Subject: Turkey Point Unit 3
Docket No. 50-250
Response to Request for Additional Information
Regarding Steam Generator Tube Plugging
Inservice Inspection Report (TAC NO. MC8112)

Response To Request For Additional Information
Regarding Turkey Point Unit 3 Steam Generator Tube Inspection Report

Figure 4-3 — Condition Monitoring Results for Loose Part Wear at EOC 20.

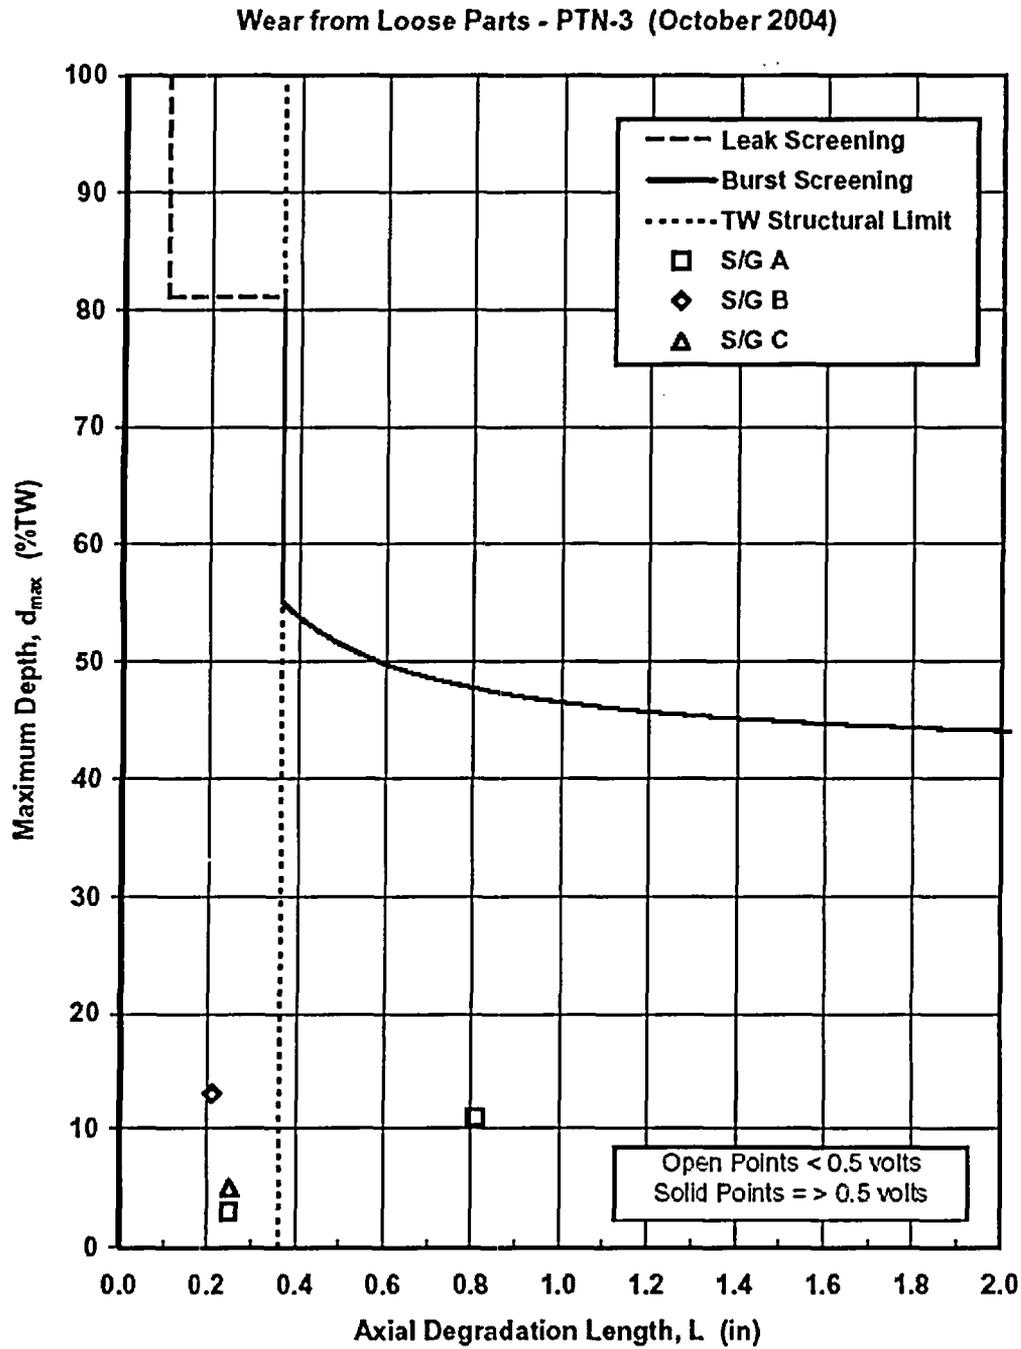
Attachment 1 of the inservice inspection report indicated that mechanical wear damage was identified in locations other than anti vibration bars (e.g., tube supports, top of tubesheet) in steam generator (SG) A, B, and C. Please explain the cause of these indications. If the indications are attributed to possible loose parts, please discuss whether a foreign object search and retrieval was performed in each SG and whether the loose parts were removed from the SGs. If the parts were not removed or the locations were not visually inspected, please discuss the results of any evaluations performed to ensure these parts (or suspected parts) would not result in a loss of tube integrity for the period of time between inspections.

There were four indications detected associated with wear from foreign objects. A comparison of these wear indications with the CM structural limits is given in Figure 4-3. Three of these indications were detected at the top of tube sheet. The wear damage was shallow and there was no evidence that the loose part was still present. The other wear indication was detected at a TSP and is due to a probable loose part. All loose part wear met the NEI 97-06 structural limit performance criterion for burst and leak integrity. No tubes required to be plugged. These tubes remain in service and will be tracked during future inspections.
